Consultation Report

Simplicity Living Te Pūtahi Ladies Mile

Prepared for Simplicity Living Limited • August 2026

Document	Consultation Report Summary Simplicity Living – Te Pūtahi Ladies Mile
Ref	720422
Date	July 2026
Prepared by	Joanne Skuse Principal Planner, The Property Group

1.4. Collector Road A (north-south along site's eastern boundary)

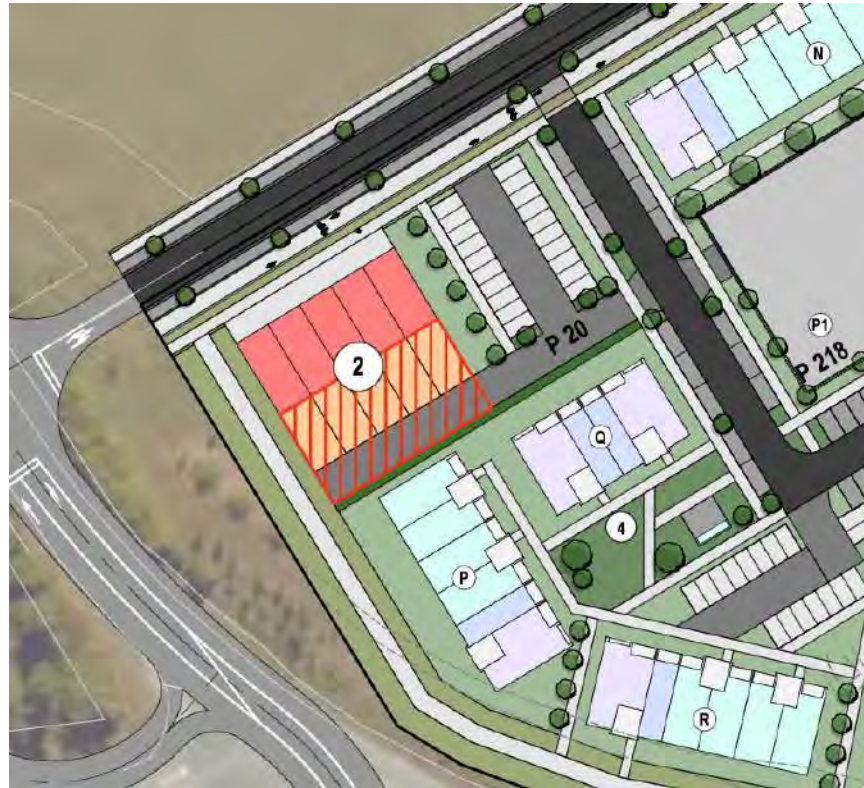
- A. We discussed the implications of removing this Collector Road from the structure plan to better utilise the applicants site design.
- B. I acknowledge that earlier iterations of the Te Pūtahi Ladies Mile Zone masterplan had explored alternative locations and hierarchy classification of this Collector Road A.

- C. I am not opposed to the applicant's proposed vested roading network on the condition that the amenity functions of the structure plan are not lost in terms of:

- The masterplan enables frequent NS active transport linkages for public access as currently provided for in adjacent development site designs. Noting the Glenpanel site has provided finer-grain connections @<100m spacings public access.

- Provision for active transport crossing points on SH6 at desire lines for people travelling to Ladies Mile from Stalker Road.
 - Evidence that the sightline to Coronet Peak and Slope Hill ridgeline looking north from Stalker Rd is kept. The applicant is to provide several images showing the correct position of the proposed building mass. This should be at both the termination of Stalker Road at the SH6 roundabout, and about 100m further south on Stalker Road.

- D. **(Action Applicant)** to address the above in next iteration of plans
